| Intersection ID: 11357 | Main Street: W_TRADE_ST | Cross Street: JOHNSON_AND_WALES_WY | Location:              | W                     |
| ADA ID: EA2045ABD1E6   | Ramp Type: BlendTrans1  | Initial Pass/Fail: Pass            | Overall Compliance: No | Severity Score: 15.25 |

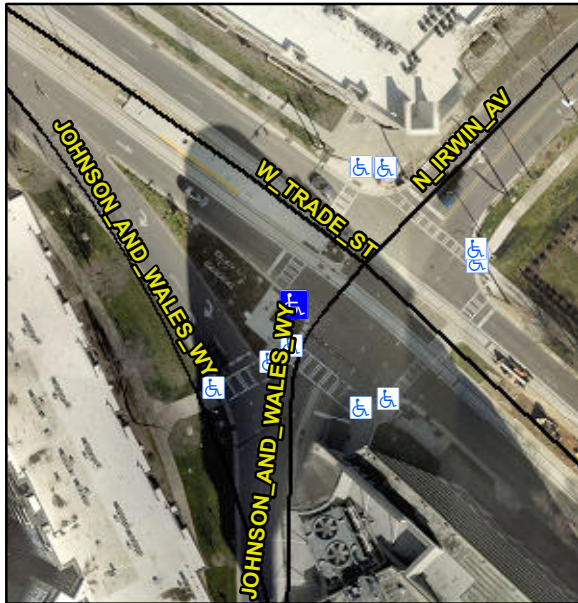
**Grind Gutter Lip. Utility Present.**

**LOCATED ON ISLAND**

**R302.7.2, R302.3, R402.2**

| Compliance      | Description           | Data  | Compliance | Description                 | Data                 |
|-----------------|-----------------------|-------|------------|-----------------------------|----------------------|
| No              | Gutter Lip Ht (in)    | 1.0   | Yes        | Gutter X Slope (%)          | 3.8                  |
| PULLBOX LIP 9.5 |                       |       |            |                             | N/A                  |
